# Hi-Fi Products Service Bulletin

**Model:** HCD-H305, HCD-H405, HCD-H605, MHC-C305, MHC-C405, MHC-C605      **No. 456**

**Subject:** Mis-operation due to wrong position of the disc tray.      **Date:** November 10, 1995

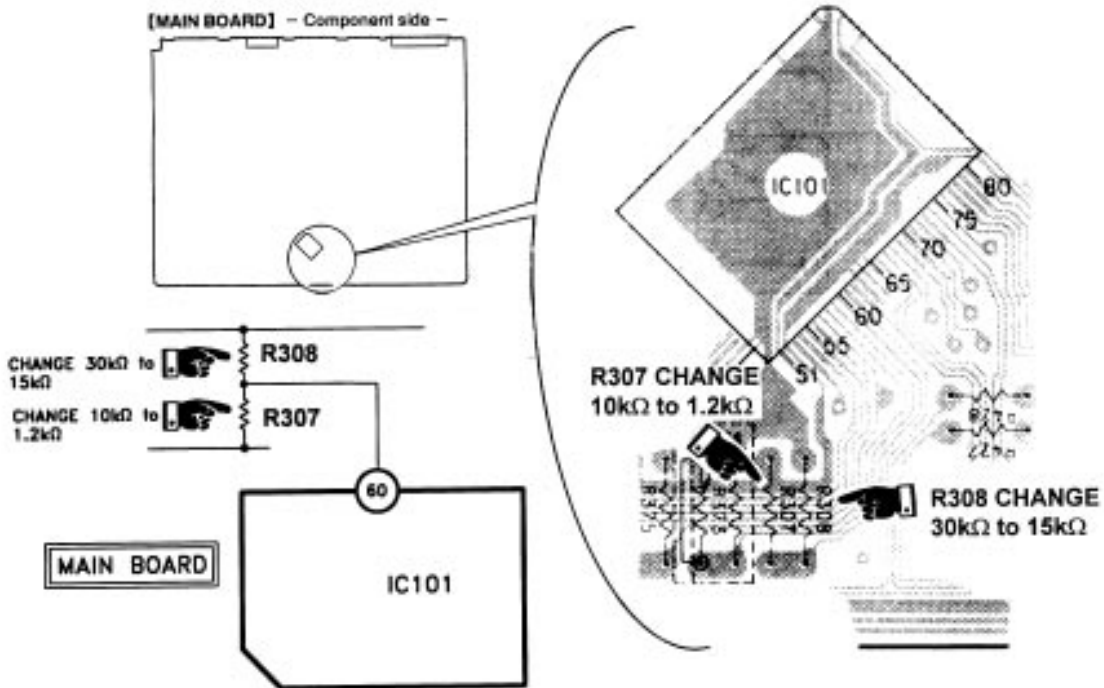
**Symptom:**  
(161) The disc tray may stop during operation.

**Solution:** If a customer complains of this, replace R307 and R308 with the new values to improve tray position sensing circuit.

REF	FORMER		NEW	
	DESCRIPTION	PART NUMBER	DESCRIPTION	PART NUMBER
R307	RESISTOR, 10K $\Omega$	1-249-429-11	RESISTOR, 1.2K $\Omega$	1-249-418-11
R308	RESISTOR, 30K $\Omega$	1-247-866-11	RESISTOR, 15K $\Omega$	1-249-431-11
